X01 Planning variation ref. How the proposal differs from approval refs. 136318/LO/2023 and 139183/FO/2024

St Margarets (App. 2),
Manchester
For Charlotte Street Estates

Roof Plan Proposed

PROJECT REF. 2093
DRWG NO. P(160)
REVISION
SCALE 1:100 @ A3
DATE 1st Aug 25
DRAWN GS

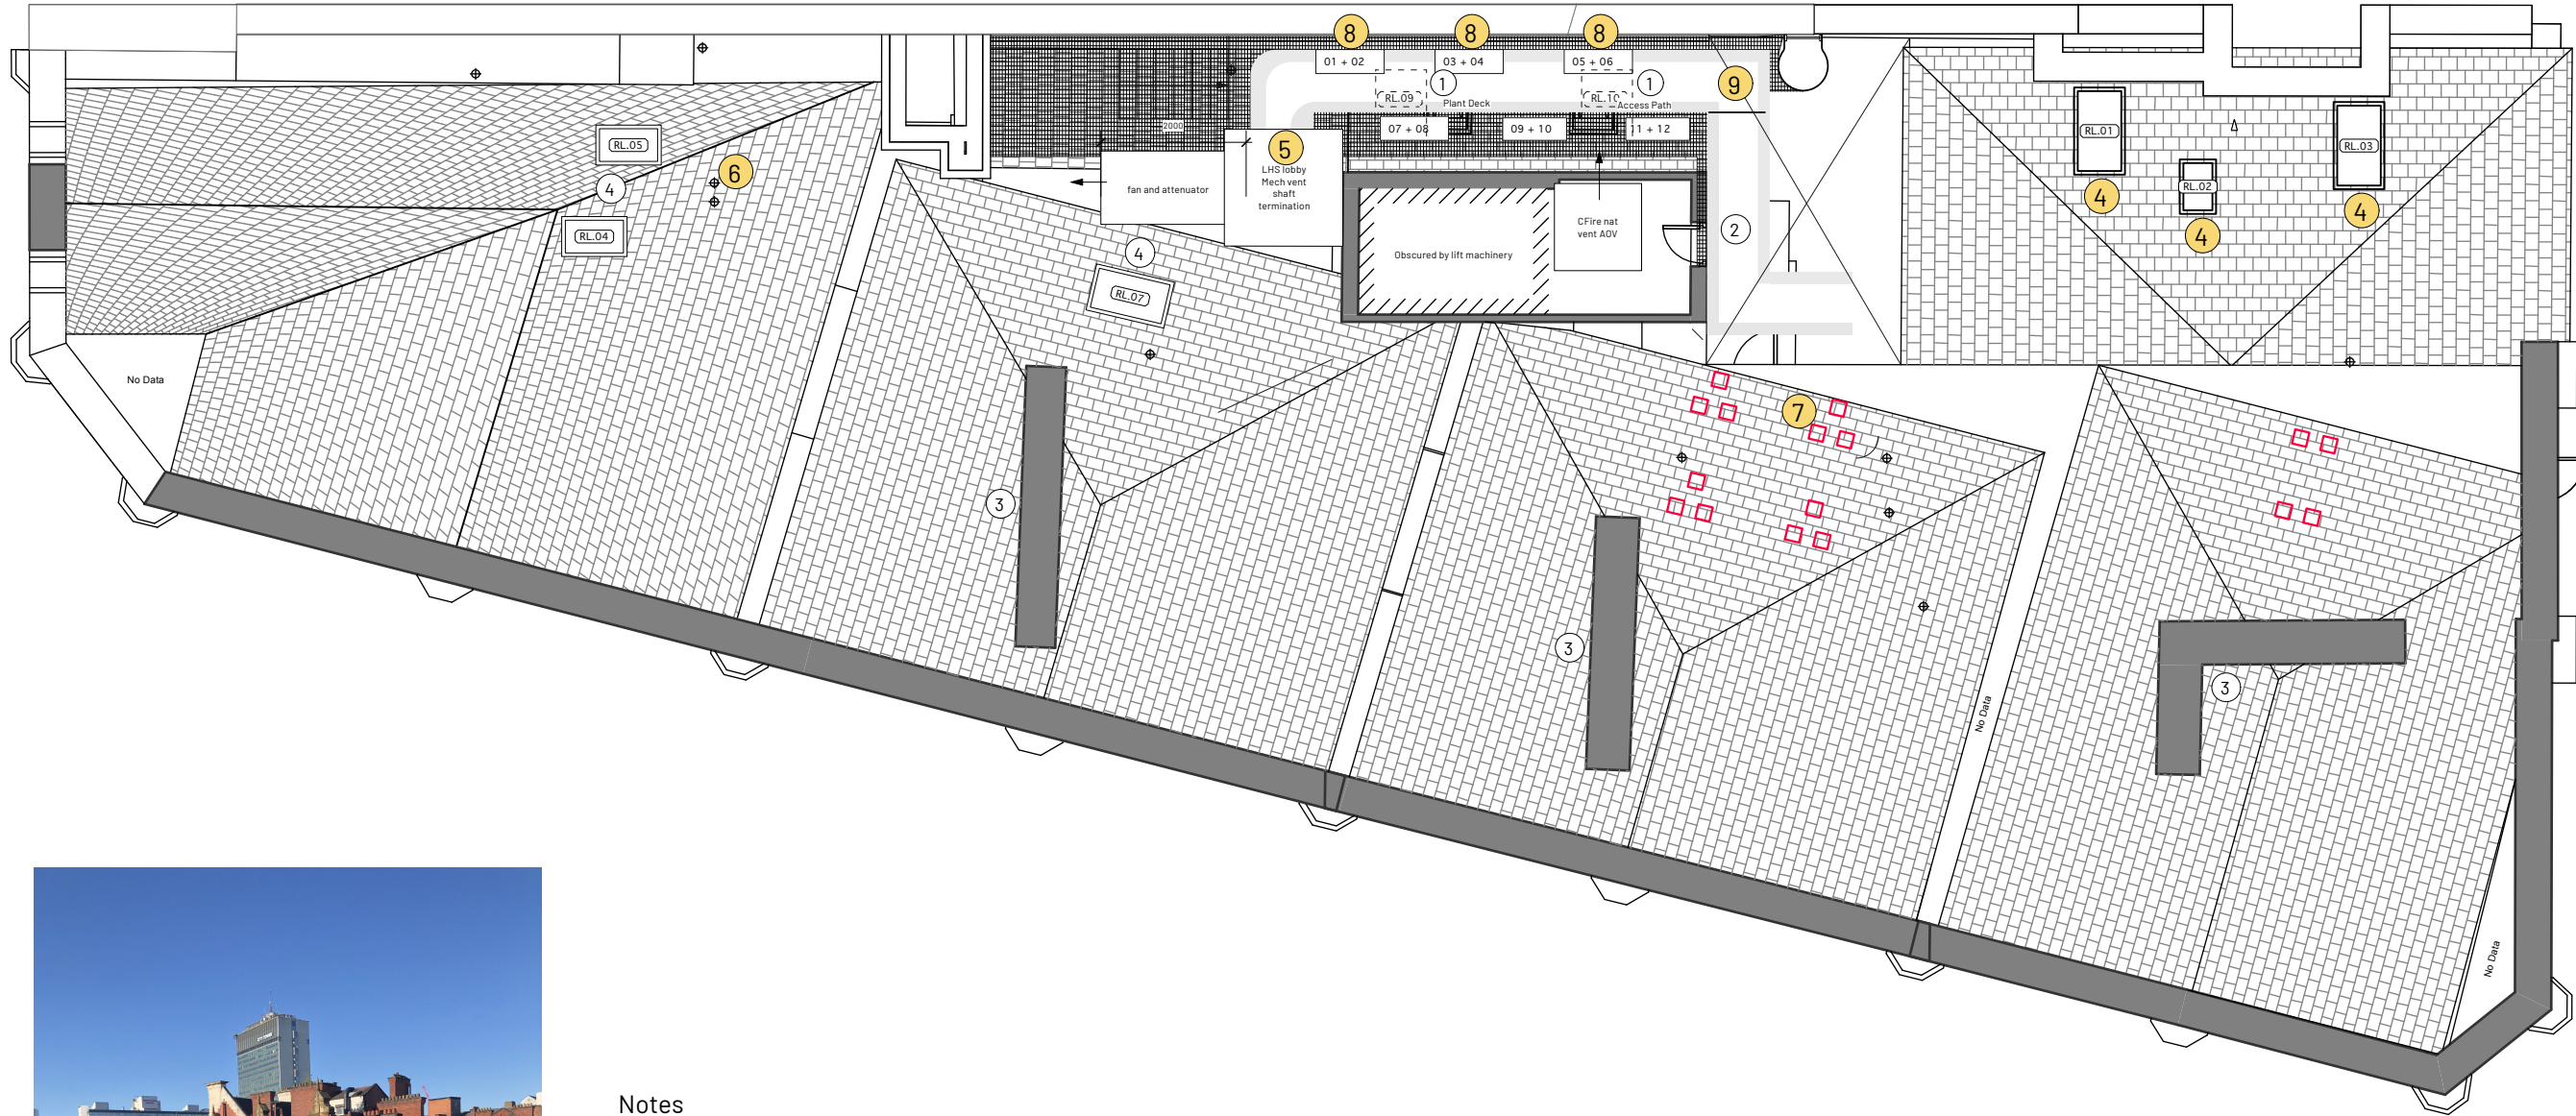
- Existing rooflights to remain.
- Existing Lightwell.
- Existing chimney stacks.
- Proposed conservation style rooflights with lead flashing. 501
- Proposed new plant deck (metal grid) and associated plant. 502
- Proposed soil vent terminations. 503
- Proposed air duct terminations. 504
- Proposed ASHP units. 505
- Smoke shaft to travel under plant deck to mechanical vent shaft. 506
